UNITED STATES PATENT AND TRADEMARK OFFICE

APPLICATION NO.	FILING DATE	FIRST NAMED INVENTOR	ATTORNEY DOCKET NO.	CONFIRMATION NO.
09/847,605	05/01/2001	Karl Jacob Haltiner JR.	DP-302846	7187

Office Action Summary

DETAILED ACTION

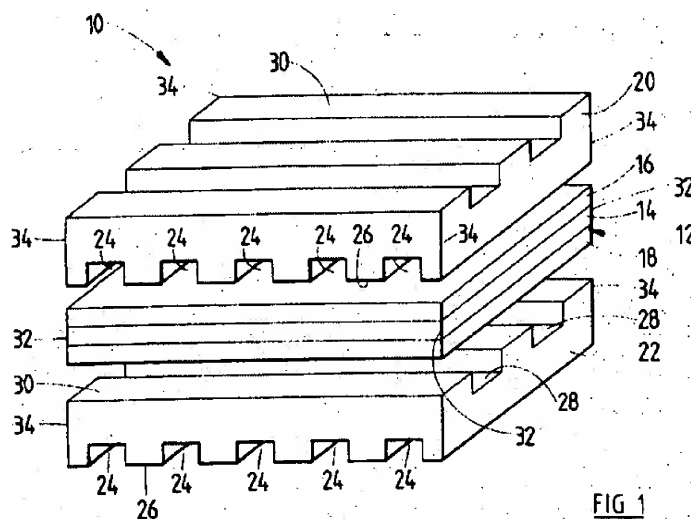
Figure 1 above illustrates a fuel cell assembly 10, the assembly comprises a fuel cell 12 comprising a solid oxide electrolyte central layer 14 with an anode layer 16 overlying one face of the electrolyte and a cathode layer 18 overlying the opposite face of the electrolyte. The fuel is sandwiched between a pair of interconnects 20, 22 which in use are in face contact with the anode 16 and cathode 18, respectively.

Figure 1 above depicts interconnects 20, 22 comprising gas flow channels 24 and 28. As can be appreciated from Figure 1, the interconnect comprises a plurality of top side surfaces 30 and underside surfaces 26 closely spaced to each other which act as contact points between the interconnect and electrode and wherein said top side surfaces 30 and underside surfaces 26 have

FIG.-2A

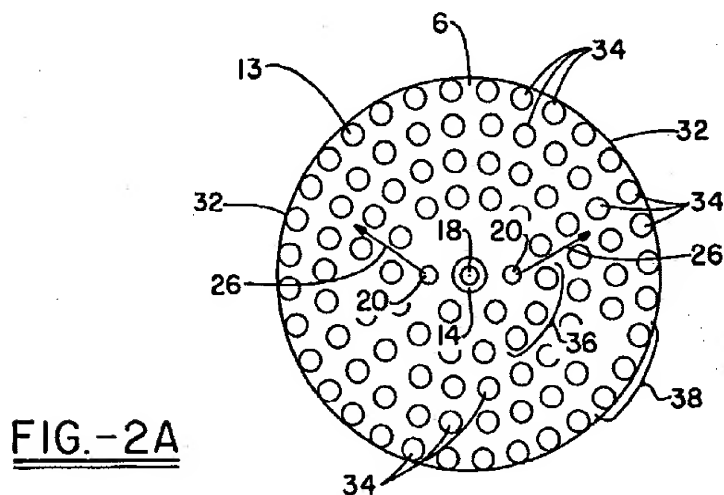
Figure 2A below shows a separator 6 defining microchannels 26 on either or both of its surfaces. Since the separators contact the anode and cathode surfaces, microchannels 26 defined within the separator surfaces provide reactant channeling (col 6, lines 33-40). A microchannel 26 may be defined by a quantity of regularly spaced circular columns 34 (*contact points*) extending between surfaces (col 6, lines 45-48). It is disclosed that it should be understood that a preferred pattern of columns 34 would utilize many more columns than shown, with each column having a diameter on the order of about 1 mm or less (col 6, lines 58-61/col 7, lines 48-52). The cell and stack diameters are typically about 50 to about 80 mm (col 5, lines 10-12). The specific contact point density is apparent upon inspection of the separator plate 6 as illustrated in Figure 2A.

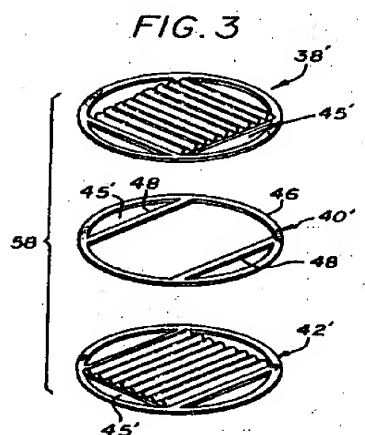
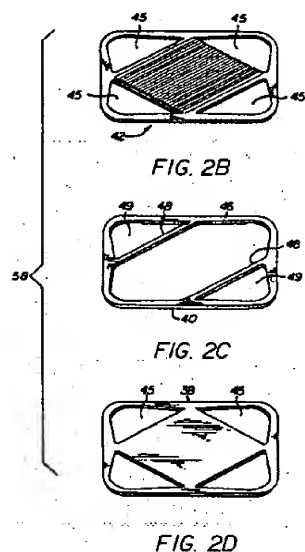
With respect to the specific flow passage depth and the surface area, it would have been obvious to one skilled in the art at the time the invention was made to make the interconnect of Badwal et al by having specified flow passage depth and surface area of Ruhl et al because Ruhl et al teaches that the specific depth of flow passage (channel) and surface area relationship should defines a channel pattern wherein the channel cross-section is enhanced such that reactant gas flowing through the passages (channel) achieves tailored local flow, pressure, and velocity distributions. Accordingly, those of ordinary skill in art would find motivation to make the

specified flow passage depth and surface area relationship in the interconnect of Badwal et al as Ruhl et al teaches that such flow passage depth and surface area relationship (overall dimension), in general, achieve a specific target overall pressure drop that minimize electrical resistance and improves reactant gas distribution.
